# City of Corpus Christi

### Planning Commission

Wednesday, February 18, 2026

**TECHNICAL REVIEW PLAT REQUIREMENTS  
REGULAR PLANNING COMMISSION MEETING  
February 18, 2026**

# PRELIMINARY PLAT OF RIVERSTONE TRAILS SUBDIVISION PHASE I

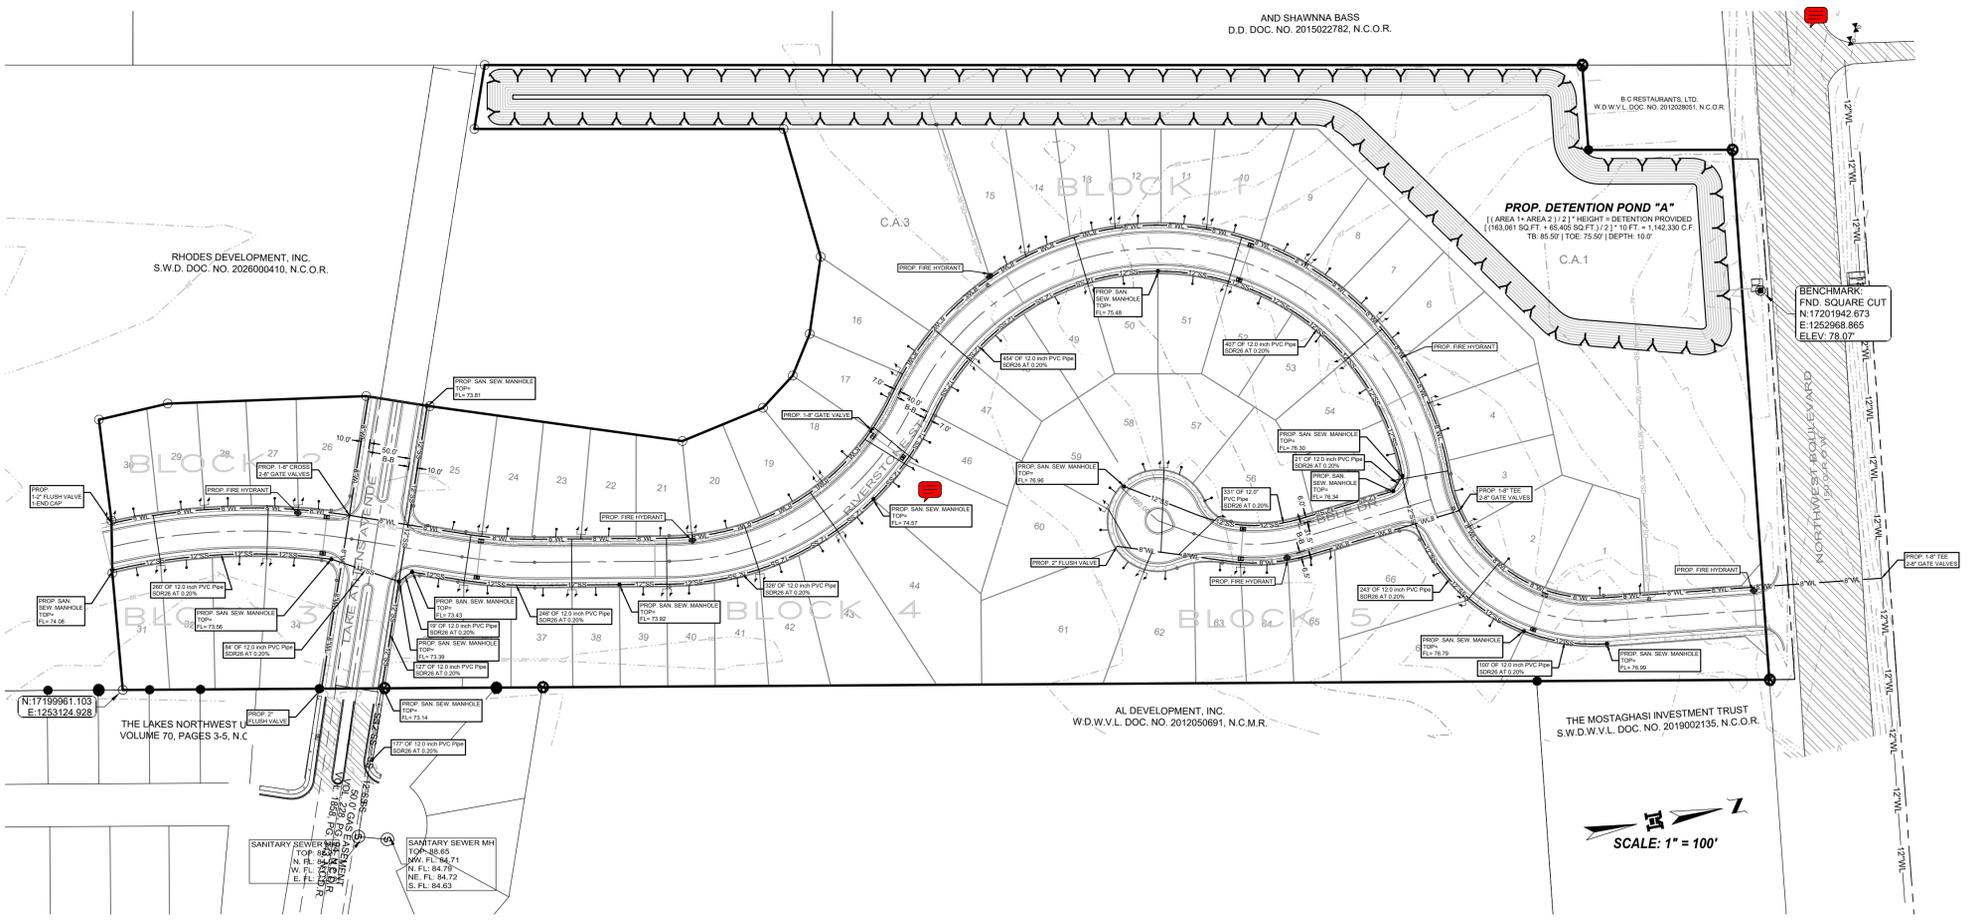
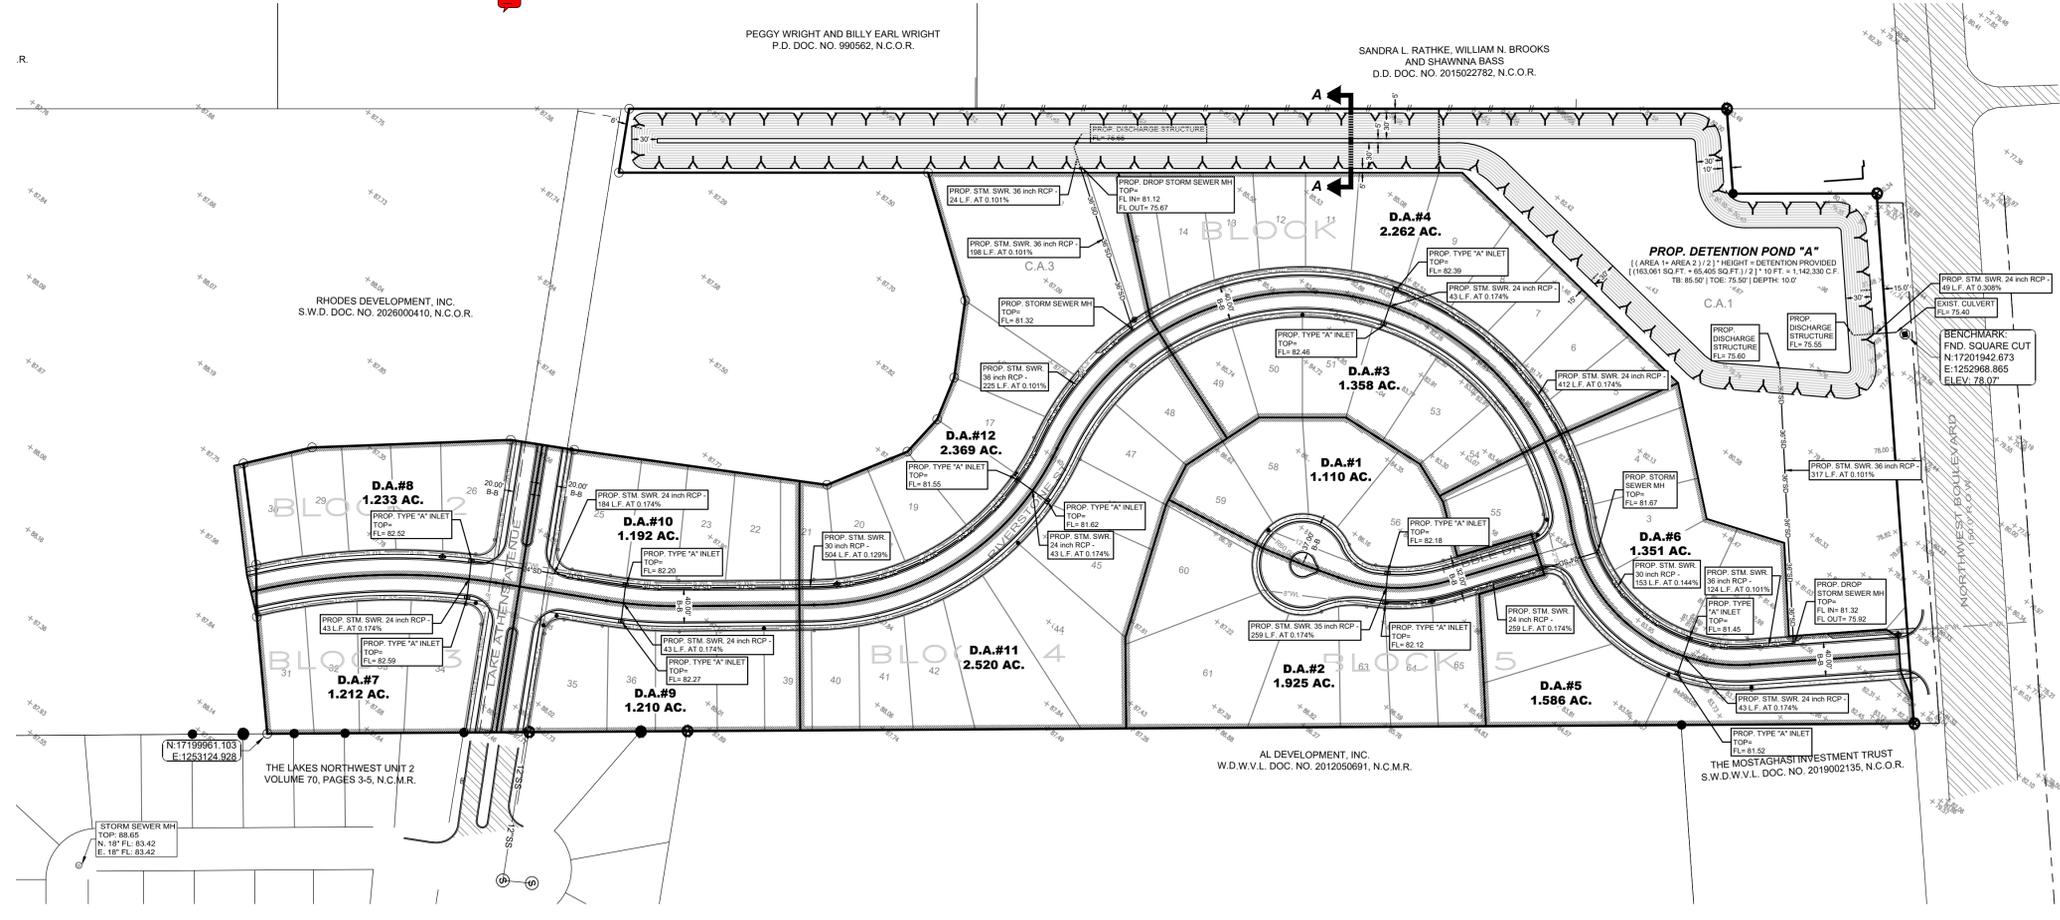
<b>Comment ID</b>	<b>Page Reference</b>	<b>Annotation Type</b>	<b>Author : Department</b>	<b>Status</b>	<b>Review Comments</b>	<b>Applicant Response Comments</b>
12	P001	Note	Bria Whitmire : DS	Closed	Being a Preliminary Plat, show boundaries of the Final Plats	
13	P001	Note	Bria Whitmire : DS	Closed	Improvements Required for Recordation, per UDC 8.1.4. A. Streets: Yes, Prior to or with Final Sidewalks: Yes, Prior to or with Final Lighting Plan: Yes, Prior to or with Final

Comment ID	Page Reference	Annotation Type	Author : Department	Status	Review Comments	Applicant Response Comments
21	P001	Note	Mina Trinidad : DS	Closed	TxDOT: (Lucio Ramos) Can I get coordinates of the center of the driveway and or proposed plan stationing to see how that fits with our proposed plan layouts of US 77 to CR 73.	
22	P001	Note	Mina Trinidad : DS	Closed	(Informational) GIS: Plat closes within acceptable engineering standards.	
23	P001	Note	Mina Trinidad : DS	Closed	(Informational) CCRTA: This plat is not located along any existing or foreseeably planned CCRTA service route.	
37	P001	Note	Mina Trinidad : DS	Closed	Traffic/ROW: (Jorge Chavez) PLAT - ROADWAY MASTER PLAN The proposed plat is impacted by the Roadway Master Plan Roadway Master Plan - project 1-AA C1 collector - 60 FT ROW dedication BB Width 40 FT Proposed plat provides a 76 FT ROW dedication - meeting minimum ROW dedication requirement  Roadway Master Plan - project 1-AE C1 collector - 60 FT ROW dedication Proposed plat does not show ROW dedication - not adhering to the Roadway Master Plan Amendment process required if plat / applicant does not wish to adhere to the Roadway Master Plan.

38	P001	Note	Mina Trinidad : DS	Closed	Traffic/ROW: (Jorge Chavez) REQUIRES ACTION: PLAT Proposed Lake Athens Ave As per COCC - UDC, C1 Collector - no median / turn lane Proposed plat / drawings show median on lake Athens Ave Use of the design with curved roadways, provide evidence regarding the design requirements / criteria is being met: City of Corpus Christi Infrastructure Design Manual 6.2.8 Sight Distance Table 6.2.8.A Minimum Required Stopping Sight Distance 6.2.11 Horizontal Curve Radii

41	P001	Note	Mina Trinidad : DS	Closed	Change "final" verbiage on plat header to "Preliminary" as this is a preliminary plat.	
42	P001	Note	Mina Trinidad : DS	Closed	Metes and bounds not required to be shown on the plat.	
43	P001	Note	Mina Trinidad : DS	Closed	Remove plat signatures. Plat is a preliminary plat, it will go to Planning Commission but will not be recorded therefore, no signature blocks are needed.	
44	P001	Note	Mina Trinidad : DS	Closed	Owner and engineer/surveyors name must be on plat.	
45	P001	Note	Mina Trinidad : DS	Closed	Ensure total platted area general plat note matches the plat heading.	
46	P001	Note	Mina Trinidad : DS	Closed	<p>02/04/26 Update: "Receiving waters" plat note should follow TCEQ standards.</p> <p>Include "Receiving waters" plat note.</p>	
48	P001	Note	Mina Trinidad : DS	Closed	<p>(Informational)</p> <p>UDC 8.1.8.B Homeowners Association Required prior to recordation.</p>

Comment ID	Page Reference	Annotation Type	Author : Department	Status	Review Comments	Applicant Response Comments
					<p>The developer shall submit a legal instrument:            (1) Establishing a plan for the use and permanent maintenance of the private improvements;            (2) Demonstrating that the homeowners association is self-perpetuating and adequately funded to accomplish its purposes;            (3) Providing the City and other governmental authorities with written permission for access at any time without liability when on official business;            and            (4) Permitting the City to remove obstructions if necessary for emergency vehicle access and to assess the cost of removal to the owner of the obstruction.</p>	
49	P001	Note	Mina Trinidad : DS	Closed	Update "Common Areas" plat note to include the common area numbers as well.	
50	P001	Note	Mina Trinidad : DS	Closed	Include street names on plat.

51	P001	Note	Mina Trinidad : DS	Closed	Provide block numbers on plat.	
55	P001	Note	Mina Trinidad : DS	Closed	<p>Fire:            (Juan Perez)            Water Distribution Standards: Fire flow for residential areas requires 750 GPM with 20 psi residual</p> <p>507.5.1 Exception 1: Group R-3 (one- or two-family dwellings): Fire hydrants to be located every 600 feet apart.</p> <p>3310.1 Required access. Approved vehicle access for firefighting shall be provided to all construction or demolition sites. Vehicle access shall be provided to within 100 feet of temporary or permanent fire department connections. Vehicle access shall be provided by either temporary or permanent roads, capable of supporting vehicle loading under all weather conditions. Vehicle access shall be maintained until permanent fire apparatus access roads are available.</p> <p>D102.1 Access and loading. Facilities, buildings, or portions of buildings hereafter constructed shall be accessible to fire department apparatus by way of an approved fire apparatus access road with an asphalt, concrete or other approved driving surface capable of supporting the imposed load of fire apparatus weighing at least 75,000 pounds.</p>

Comment ID	Page Reference	Annotation Type	Author : Department	Status	Review Comments	Applicant Response Comments
57	P001	Note	Mina Trinidad : DS	Closed	(Informational) RMP C1 collector street within phase 1 development.	
58	P001	Note	Mina Trinidad : DS	Closed	Topographic contours to be shown on plat.	
59	P001	Note	Mina Trinidad : DS	Closed	(Informational) TxDOT: (Lucio Ramos) Drainage will be reviewed when driveway permit is requested.	
60	P001	Note	Mina Trinidad : DS	Closed	Update plat ownership and deed number within plat boundary.	
61	P001	Note	Mina Trinidad : DS	Closed	Include adjacent property owner information, Lake Athens Avenue continuation, and easements of adjacent properties within 200-feet of subject property. (This information was included on previous submittal of plat)	
16	U001	Note	Bria Whitmire : DS	Closed	Design Details to be confirmed on Construction Plans	
17	U001	Note	Bria Whitmire : DS	Closed	Notate the application of this cross section- assuming the cul d sac in comparing the B-B provided on the D&G sheet but provide references on all sheets to ensure clarity.

18	U001	Note	Bria Whitmire : DS	Closed	Details of service connections around cul d sac to be further addressed on construction plans.	
24	U001	Note	Mina Trinidad : DS	Closed	(Informational) Gas Department has no comment.	
25	U001	Note	Mina Trinidad : DS	Closed	(Informational) Equistar Pipeline will not be involved, no comment.	
52	U001	Note	Mina Trinidad : DS	Closed	(Informational) AEP Distribution has no comment.	
53	U001	Note	Mina Trinidad : DS	Closed	CCW: (John Gonzalez) Water Water construction is required for platting (UDC 1.2.1.D & 8.2.6; Water Distribution Standards). Additional comments of the proposed water plan & profile to be provided during Public Improvements Phase. Wastewater Wastewater construction is required for platting (UDC 1.2.1.D & 8.2.7; Wastewater Collection System Standards). Additional comments of the proposed wastewater plan & profile to be provided during Public Improvements Phase.

Comment ID	Page Reference	Annotation Type	Author : Department	Status	Review Comments	Applicant Response Comments
54	U001	Note	Mina Trinidad : DS	Closed	AEP: 02/05/26 Update: No above ground improvements are allowed 100' within our ROW (50 ft from centerline). (See documents titled "CE Jolley Easement" in attachments).  (Ronika Moralez) AEP Transmission does have an overhead power line but I believe it is not in Phase 1. I can send you my comments when I locate the easement.	
14	U002	Note	Bria Whitmire : DS	Closed	Minimum Slope is 3:1	
15	U002	Note	Bria Whitmire : DS	Closed	Provide Cross Section for all street types, including the 50' ROW, 60' ROW, 76' ROW and cul d sacs	
26	U002	Note	Justin Phung : STREET	Closed	PW STR: Per UDC Sec. 3.1.6.B, please provide typical cross section of proposed streets and/or Mobility Plan facilities consistent with latest UDC and Infrastructure Design Manual (On Preliminary Plat and Final if not provided on a previous Preliminary plat).

27	U002	Note	Justin Phung : STREET	Closed	PW STR: The developer shall be required to utilize the most stringent of sections per classification of roadway without a Geotech report validating the soil type. Please refer to IDM when constructing pavement section.	
28	U002	Note	Justin Phung : STREET	Closed	PW STR: For typical street section details, please denote planned street classification per UDC 8.2.1.B standards	
29	U002	Note	Justin Phung : STREET	Closed	PW STR: Please provide typical street section specifications on pavement section materials and thicknesses.	
30	U002	Note	Justin Phung : STREET	Closed	PW STR: Per IDM Table 6.3.5H, the road section cross-slope from the crown to the gutter shall be a consistent 2% minimum.	
31	U002	Note	Justin Phung : STREET	Closed	PW STR: Per IDM Table 6.3.5I, Only TxDOT Type A, Gr. 1-2 crushed limestone base allowed on City roadway projects without pre-approval.

62	U002	Note	Justin Phung : STREET	Closed	PW STR: Informational - For PI, please provide geotech report for determining validity of street sections.	
64	U002	Note	Justin Phung : STREET	Closed	PW STR: Is it planned to have the median for the 76' ROW match what is existing for Lake Athens Avenue? Please coordinate with Public Works Stormwater Department to determine the construction of these.

REPLAT OF:

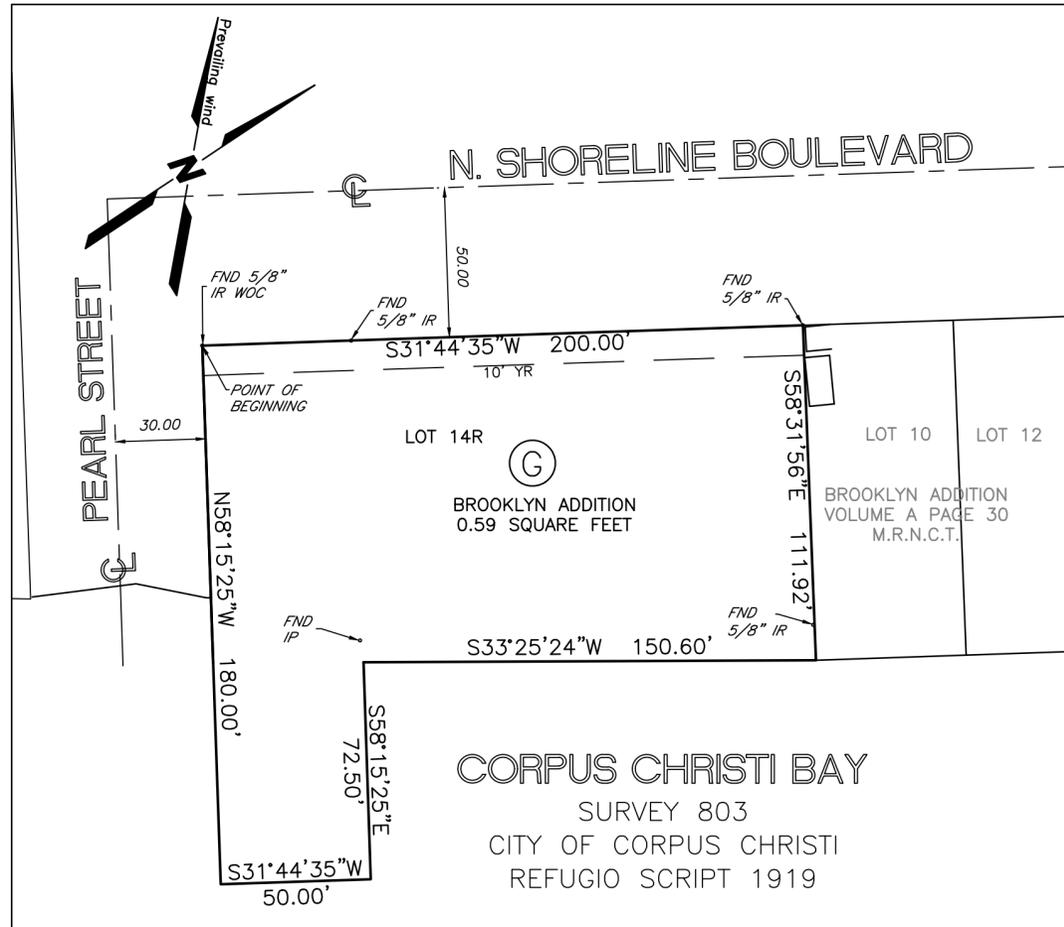
<b>Comment ID</b>	<b>Page Reference</b>	<b>Annotation Type</b>	<b>Author : Department</b>	<b>Status</b>	<b>Review Comments</b>	<b>Applicant Response Comments</b>
1	P001	Note	Mark Zans : DS	Closed	There are still plat documents needed for the completeness check. Please provide a copy of the latest deed showing the owner of the property. Application states Tinta Negra LLC and the plat shows Kenneth Berry / Beacon International.

Comment ID	Page Reference	Annotation Type	Author : Department	Status	Review Comments	Applicant Response Comments
2	P001	Note	Mark Zans : DS	Closed	Be advised that there times when a 30-day review process is not enough time for comments and responses to be process. If comments are left unaddressed then the plat can be taken to Planning Commission with a recommendation of denial. In order to avoid this, please send a e-mail stating that the application can be modified to a 60 day review time.	
4	P001	Note	Bria Whitmire : DS	Closed	Improvements Required for Recordation, per UDC 8.1.4. A. Streets: No Sidewalks: No B. Water: No Fire hydrants: No C. Wastewater: No D. Stormwater: No E. Public open space: No F. Permanent monument markers: No Please note, improvements required should be constructed to city standards, found in Article 8 and the IDM.	
5	P001	Note	Bria Whitmire : DS	Closed	Update 1.28.26: Plat still not showing portion of property extending to the southeast which includes a structures with utilities. Indicate this to assure private utility easements are appropriately placed on the plat.  Show remaining 50' x 72' of Brooklyn Blk 4265 Lot 2 as neighboring lot and provide private utility easements and access easements to assure this remaining portion is not cut off.

3	P001	Note	Mark Zans : LD	Closed	NCAD comment; Be advised that lot 2 and lots 4,6, and 8 according to NCAD are under different ownership. Tinta Negra owns lots 4 thru 8 and Channel Investments owns lot 2. All lots must be under one ownership to proceed with plat review.	
6	P001	Note	Mark Zans : LD	Closed	Change chairman name to Cynithia Salazar- Garza  Change Chairman to Chairperson	
7	P001	Note	Mark Zans : LD	Closed	Change Michael Dice title to Director	
8	P001	Note	Mark Zans : LD	Closed	Remove elevation /contour lines from plat.	
9	P001	Note	Mark Zans : LD	Closed	Remove old plat information. Add square footage of lot being platted.	
10	P001	Note	Mark Zans : LD	Closed	Remove the name of the company (Beacon International) in the ownership certification. Name should reflect ownership shown on deed.	
11	P001	Note	Mark Zans : LD	Closed	Change lot to 14R	
12	P001	Note	Mark Zans : LD	Closed	change lot number to 14R
